Portland Harbor Superfund Site: Proposed Plan & Feasibility Study

Dr. Peter deFur, QEP

Environmental Stewardship Concepts, LLC

August 31, 2016

Figure 11f., 2016 Portland Harbor Proposed Plan

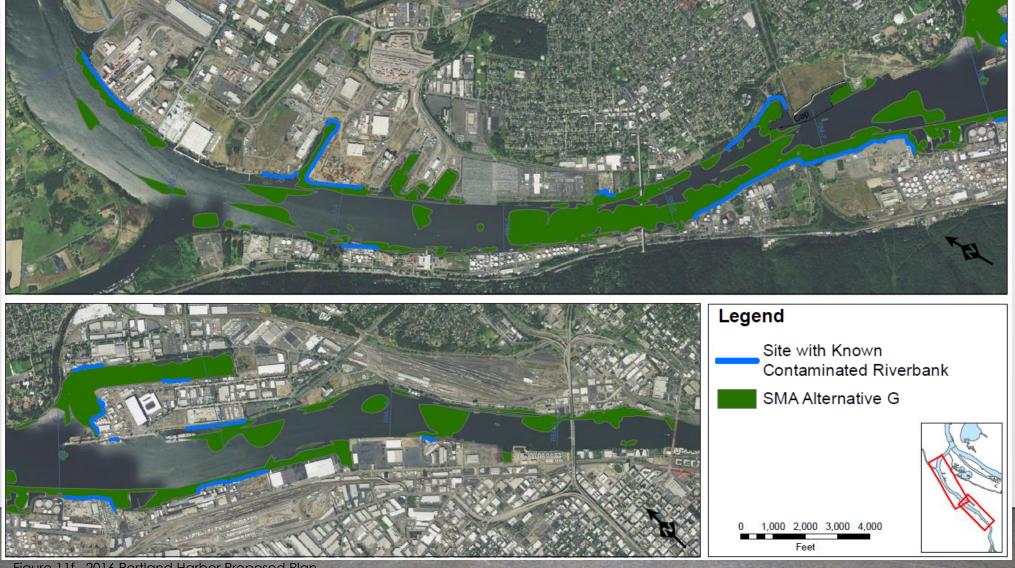
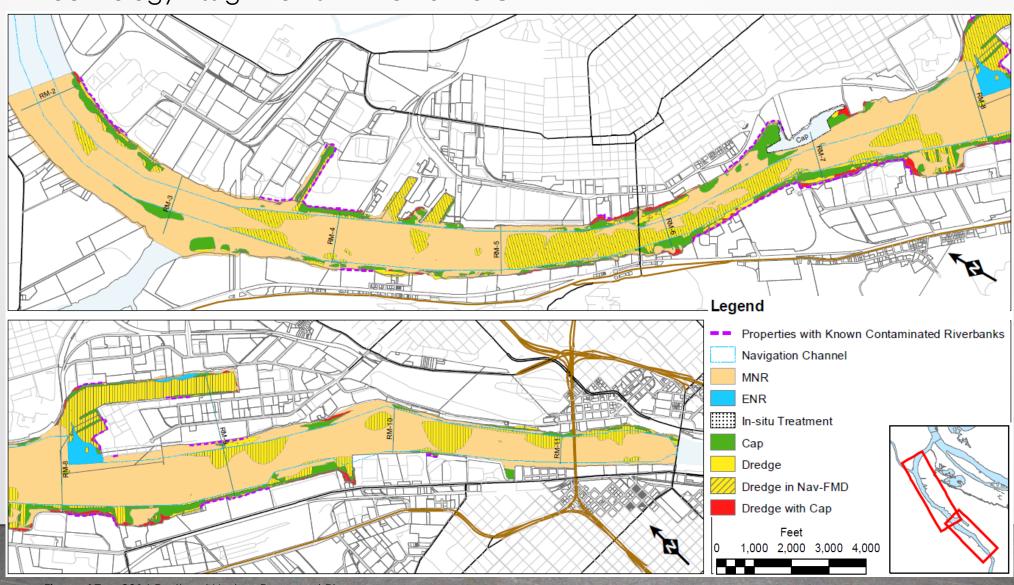
Alternative G Enhancements

- Increased shoreline remedial action
- Increased dredging--Remove additional contaminated surface sediments
